REZONING OF
127-133 PARK ST, N.E.
TOWN OF VIENNA, VIRGINIA

**PLANS APPROVED BY
FIRE MARSHAL**
--- ZONING APPROVAL ONLY ---
DATE: 06/15/2022
REVIEWER: M. PARUTI
REVIEW ID: 80519

OFFICE OF THE FIRE MARSHAL
FAIRFAX COUNTY, VIRGINIA
REVIEW ID: 80519

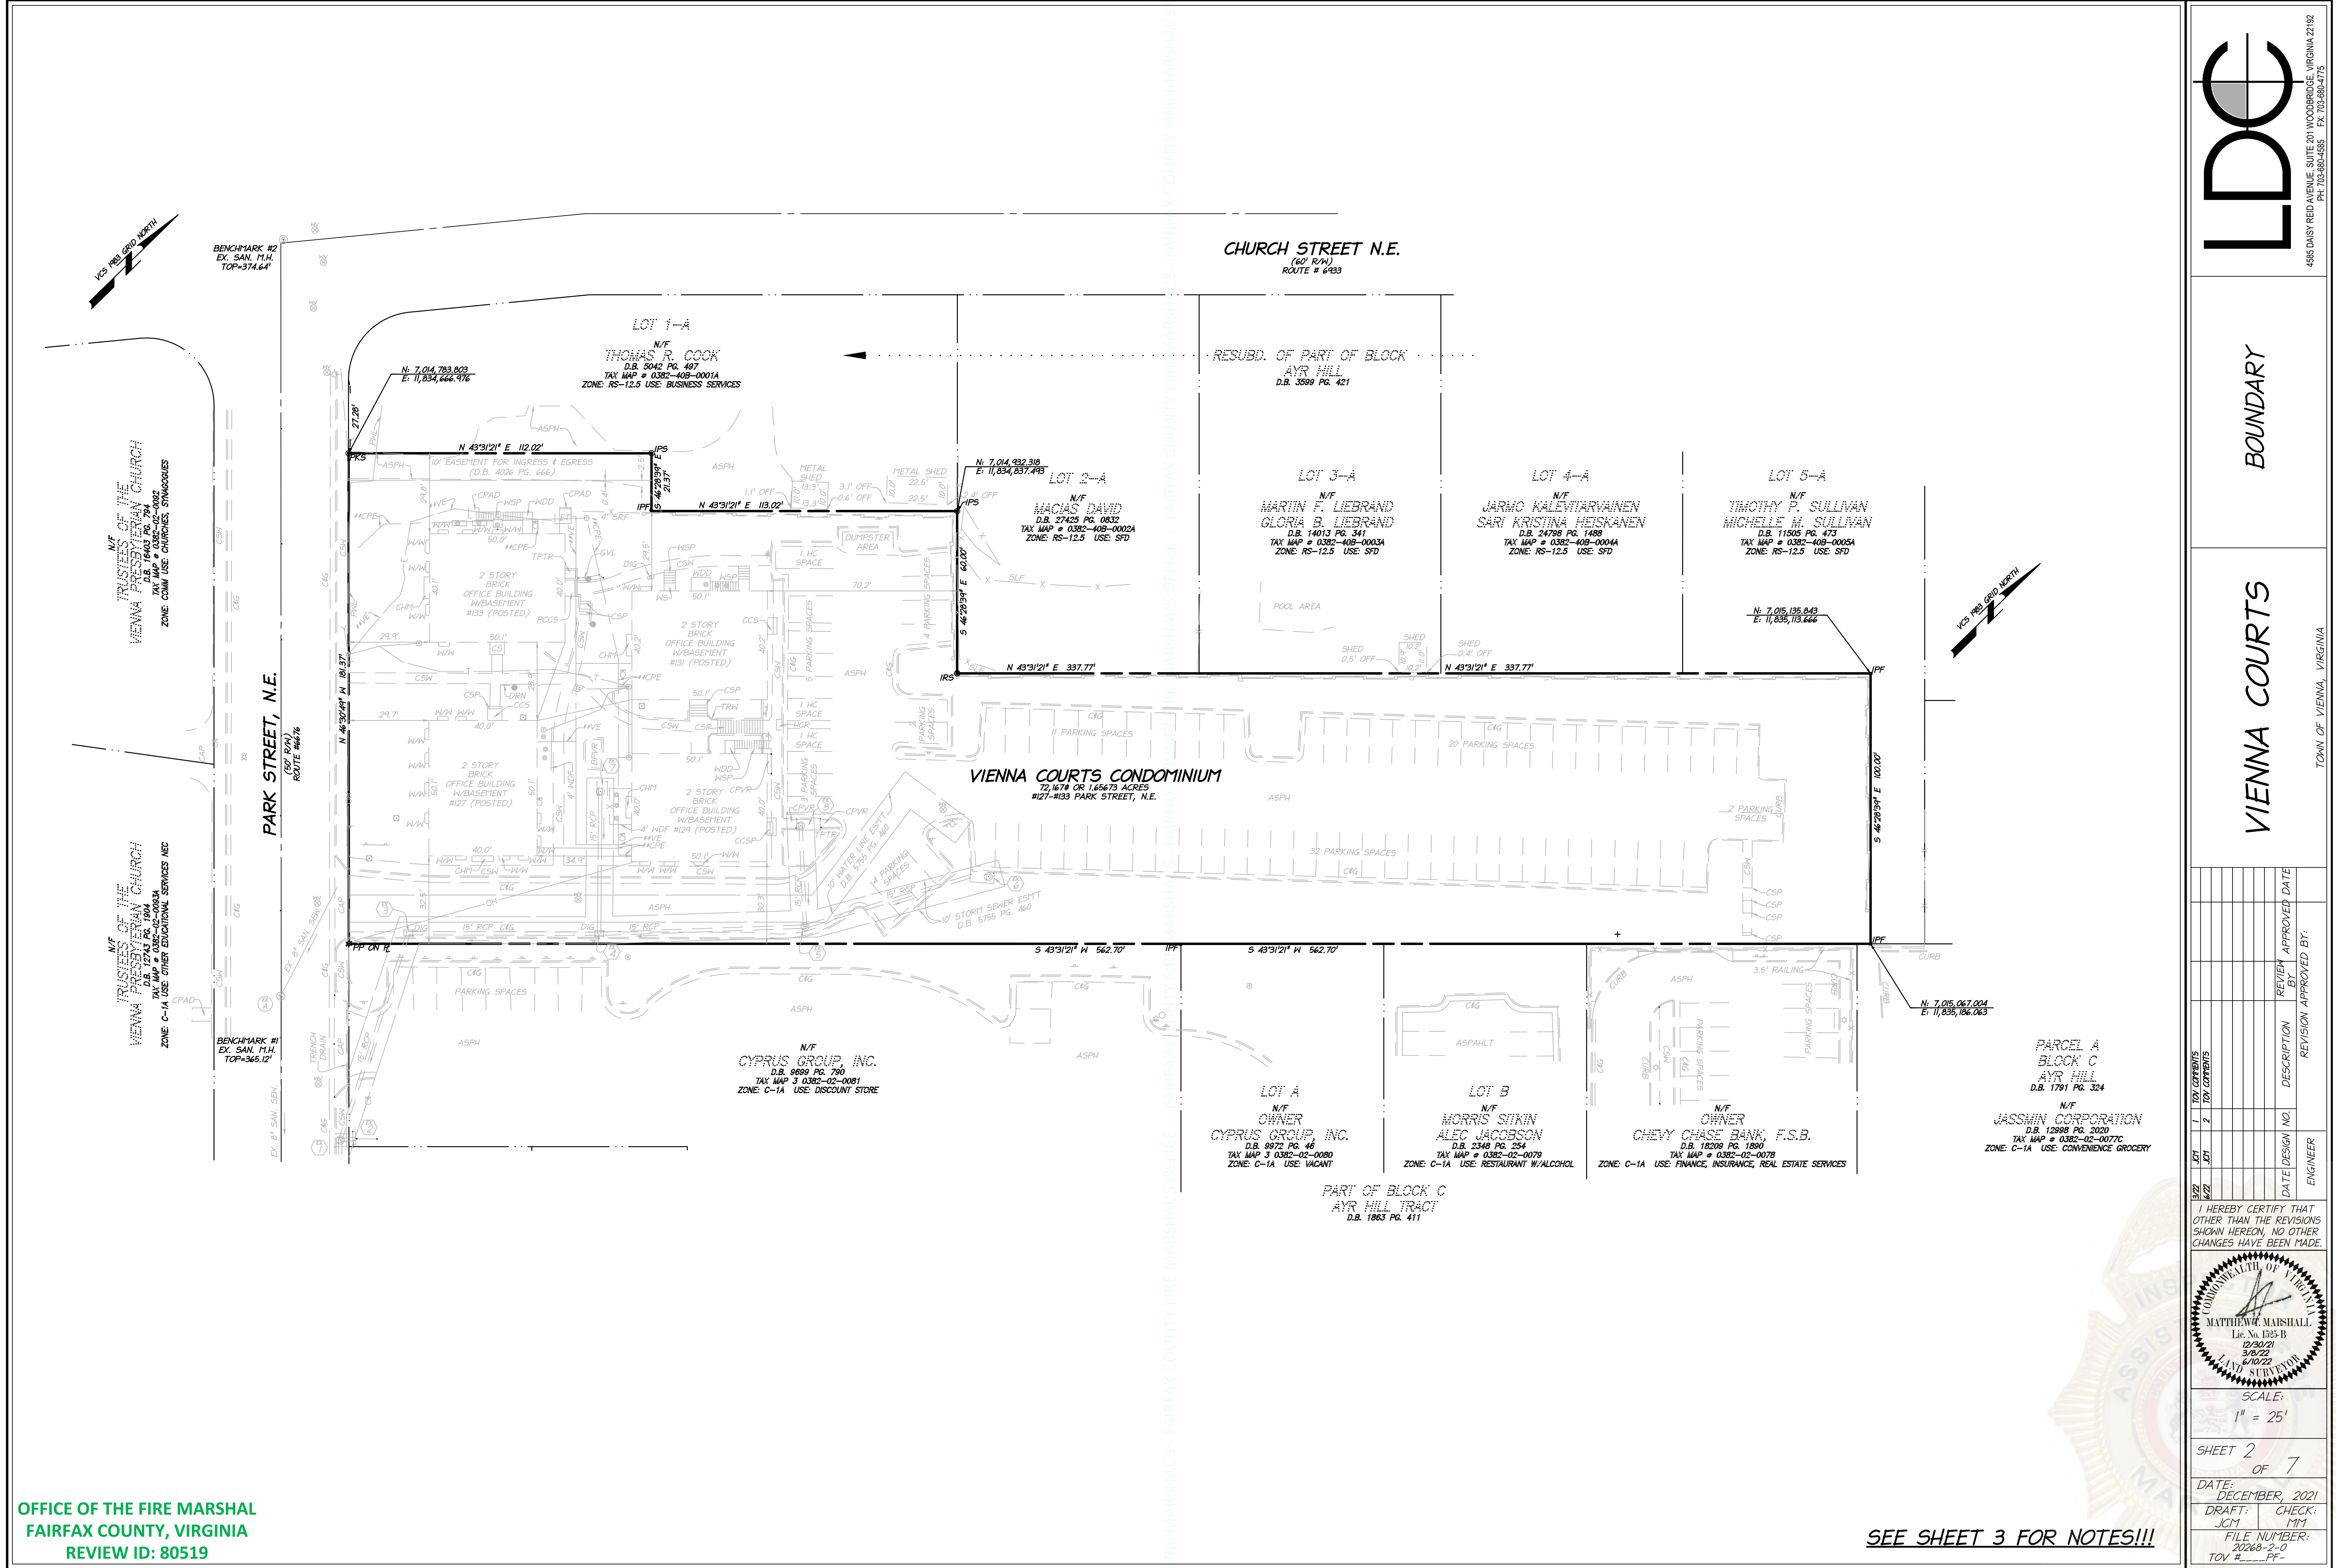
FM REVIEWER COORDINATED EXTENSIVELY WITH APPLICANT REGARDING PROPOSED LAYOUT IN ORDER TO ATTAIN AT LEAST MINIMAL COMPLIANCE WITH THE FAIRFAX COUNTY PFM AND VIRGINIA BUILDING AND FIRE CODES RELATIVE TO FD ACCESS.

MINIMAL CODE COMPLIANCE HAS BEEN ACHIEVED; HOWEVER, THIS PROPOSED LAYOUT IS FAR FROM IDEAL AND THE DELETION OF ANY STRUCTURES WOULD BE WELCOMED. ALSO, EACH OF THE STRUCTURES WILL MORE THAN LIKELY NEED TO BE SPRINKLERED VIA CODE MODIFICATION DUE TO INSUFFICIENT AVAILABLE FIRE FLOW.

FIRE MARSHAL PLAN

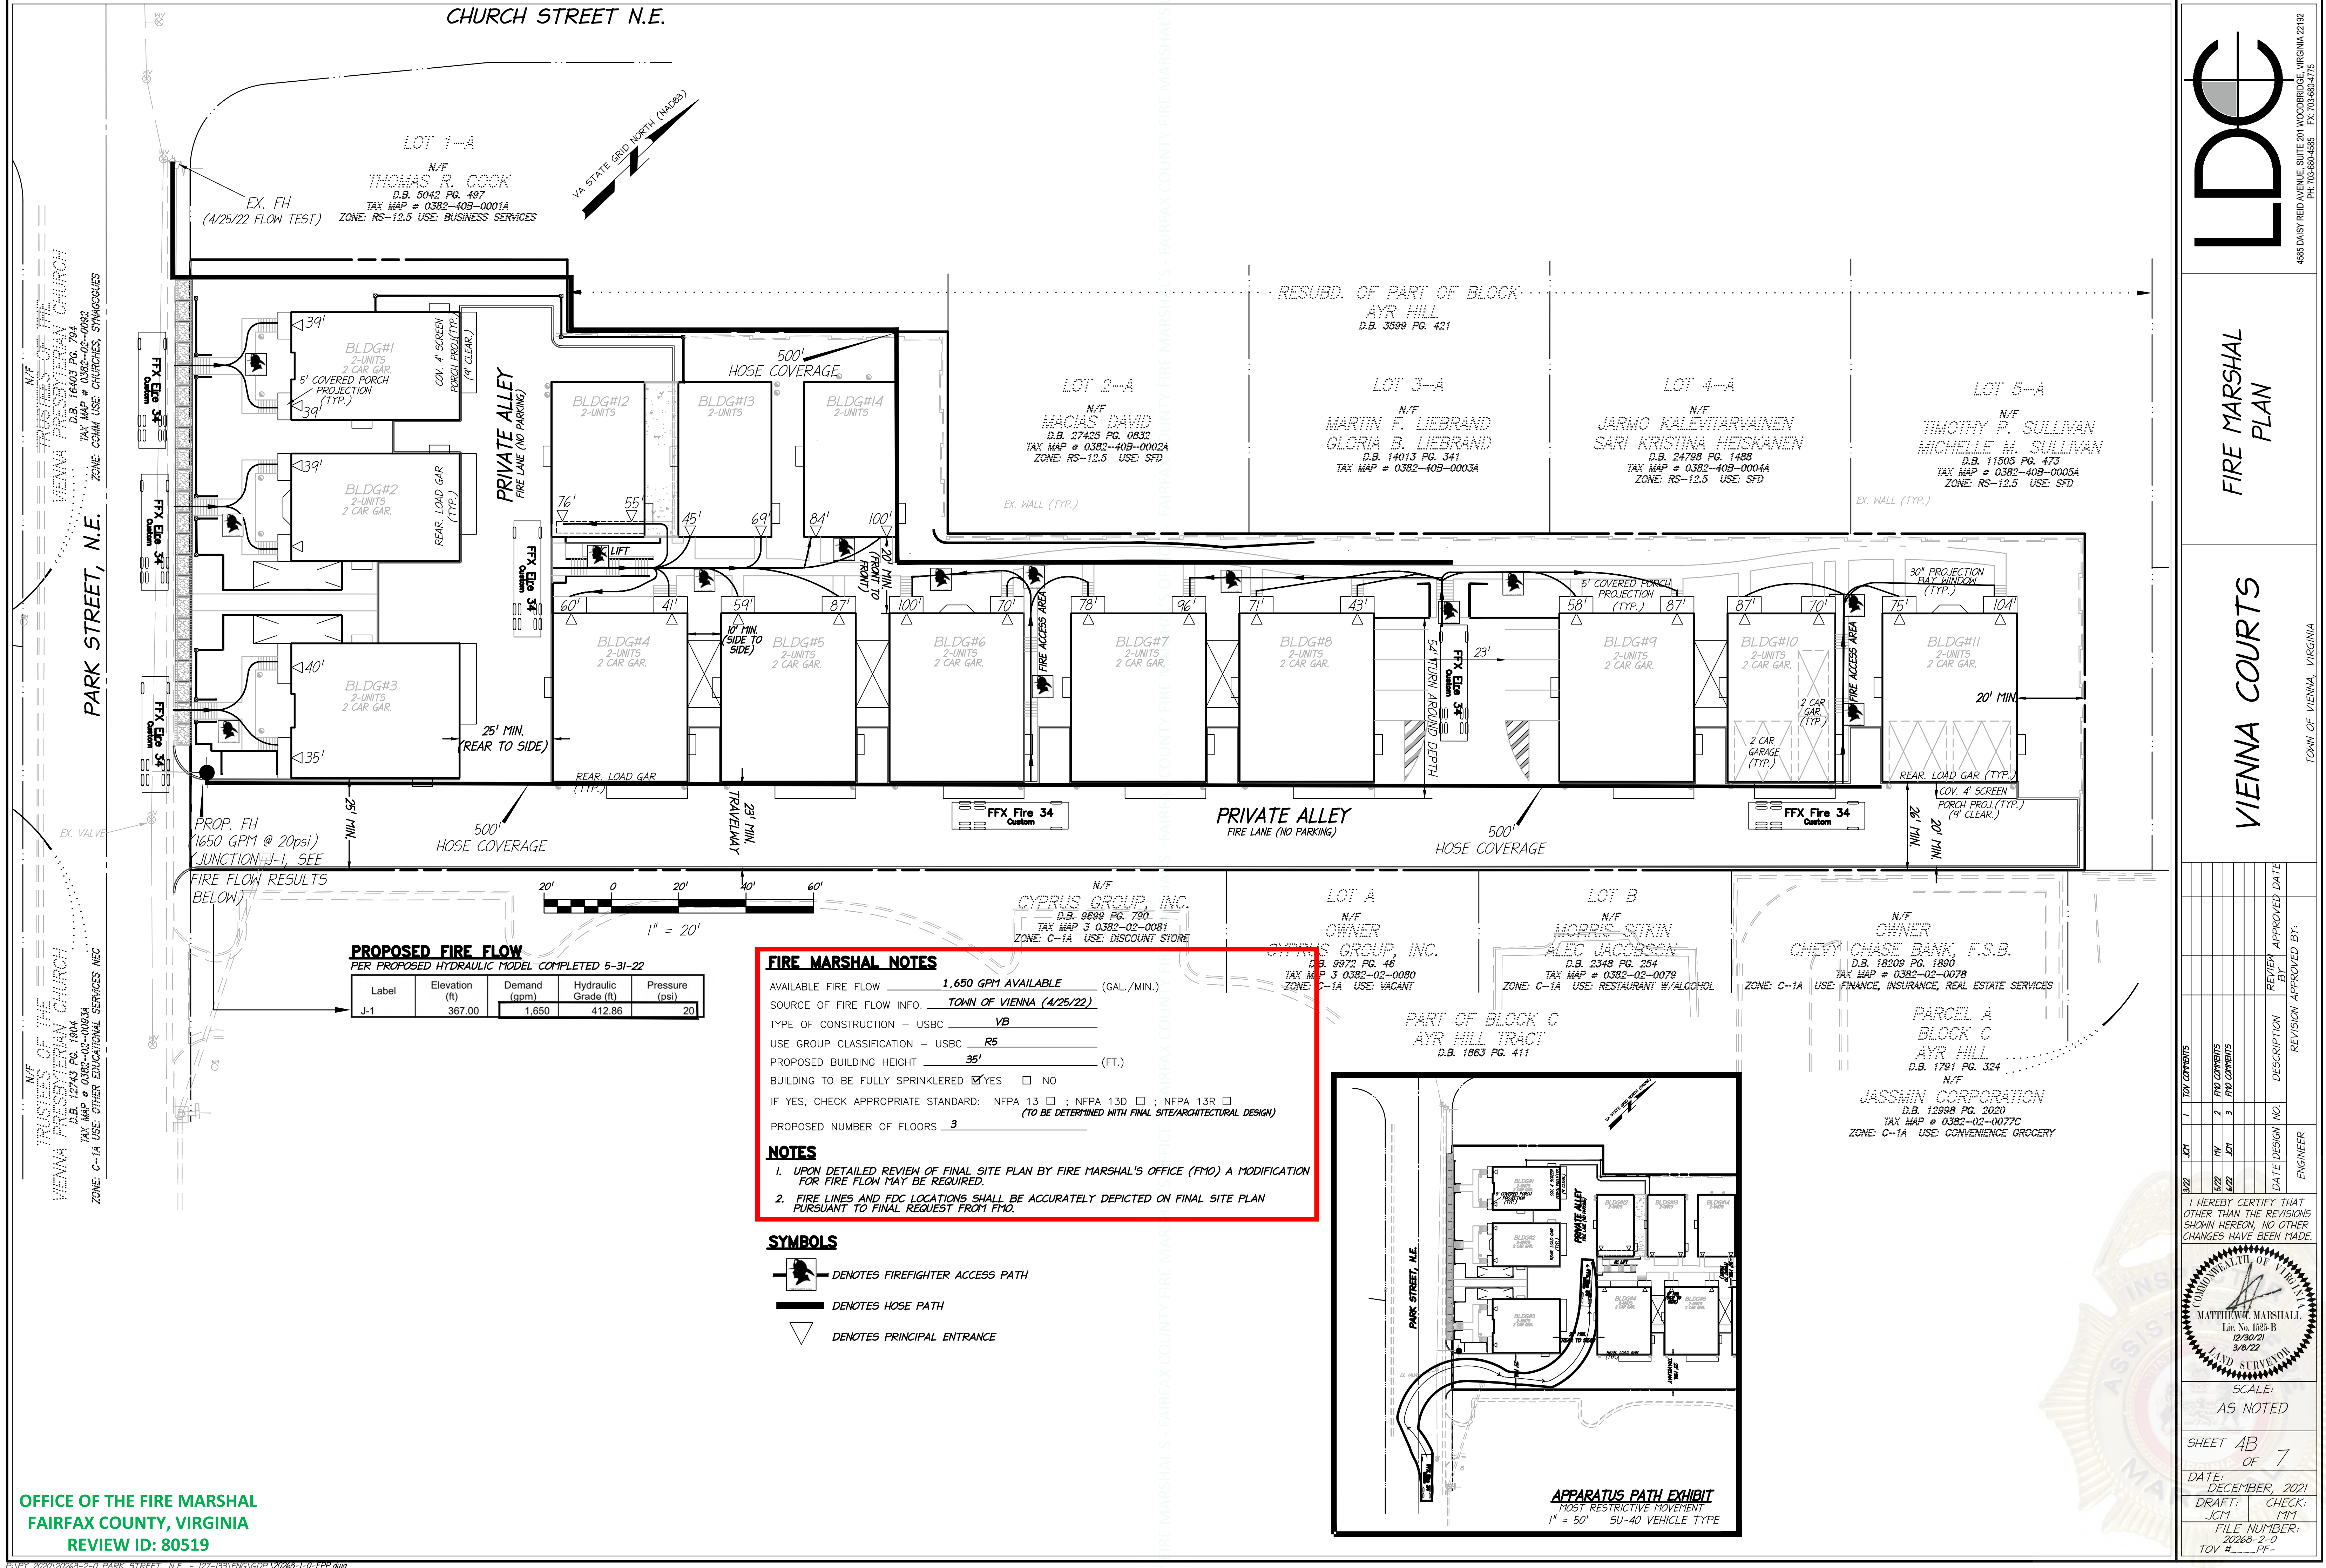
- UPON DETAILED REVIEW OF FINAL SITE PLAN BY FIRE MARSHAL'S OFFICE (FMO) A MODIFICATION FOR FIRE FLOW MAY BE REQUIRED.
- FIRE LINES AND FDC LOCATIONS SHALL BE ACCURATELY DEPICTED ON FINAL SITE PLAN PURSUANT TO FINAL REQUEST FROM FMO.
